TRANS/WP.29/GRSP/2003/3/Rev.1  
19 September 2003

Working Party on Passive Safety (GRSP)  
(Thirty-fourth session, 8-12 December 2003,  
agenda item B.1.2.)

PROPOSAL FOR DRAFT AMENDMENTS TO REGULATION No. 17  
(Strength of seats)

Revision 1

Annex 5, the figure, amend to read:

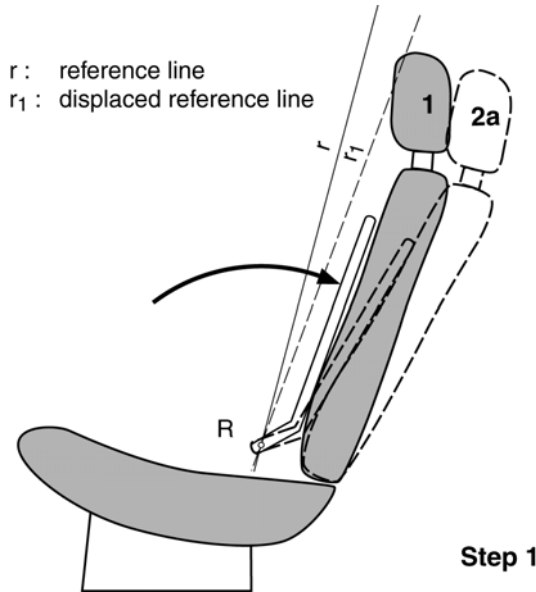
Note: The text reproduced below was prepared by the expert from the Czech Republic in order to update the proposal for the figure of annex 5 to the Regulation (TRANS/WP.29/GRSP/33, para. 21).

1. Original unloaded position.
- 2a. Displaced position by applying to the manikin's back a moment of 373 Nm about the R point, defining the position of the displaced reference line r<sub>1</sub>.
- 2b. Displaced position by applying to the 165 mm sphere a force F producing a moment of 373 Nm about the R point, keeping the displaced reference line r<sub>1</sub> in place.
3. Position after displacement by the force F increased to 890N.
